UNITED STATES PATENT AND TRADEMARK OFFICE

APPLICATION NO.	FILING DATE	FIRST NAMED INVENTOR	ATTORNEY DOCKET NO.	CONFIRMATION NO.
10/743,854	12/22/2003	Kunitake Matsushita	31647-5	9104

Office Action Summary

DETAILED ACTION

**FIG. 1**

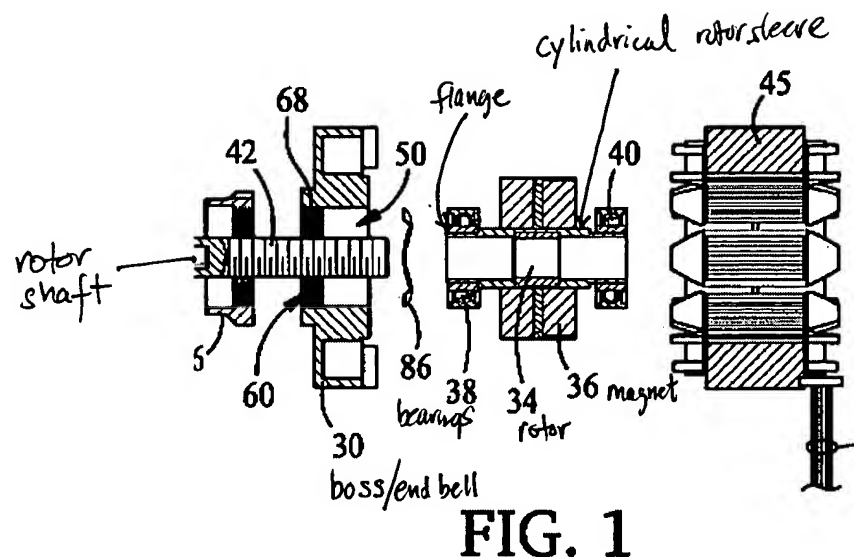
6. Claims 1, 6 and 8 are rejected under 35 U.S.C. 102(e) as being anticipated by Toye (US 6,603,229). Toye teaches a motor comprising: a rotor 34 including a shaft (not numbered; Fig.1) and a magnet 36 surrounding a portion of the shaft; a stator 45 surrounding the magnet of the rotor with a gap therebetween (not numbered, Fig.2), and adapted to generate a magnetic field thereby causing the rotor to rotate around an axis of the shaft (inherent); a rotor sleeve having a cylindrical portion (not numbered, Fig.1) and a flange (not numbered, Fig.1) provided at one end of the cylindrical portion, the rotor sleeve being provided between the magnet and the shaft so as to fixedly hold the magnet and the shaft together (Fig.2); a boss (end bell) 30 having a circular shape with a center hole 50 for allowing the shaft to rotatably pass therethrough (Fig.1), and being fixedly attached to the stator 45 so as to oppose the flange of the rotor sleeve (Fig.2); and a plurality of bearing balls 38 rotatably disposed between the boss and flange of the rotor sleeve (Fig.2).

Regarding claim 6, note sleeve bearing 80 (Figs.1&2).

Regarding claim 8, one exposed end 42 of the shaft comprises a threaded, spiral portion (Fig.2).
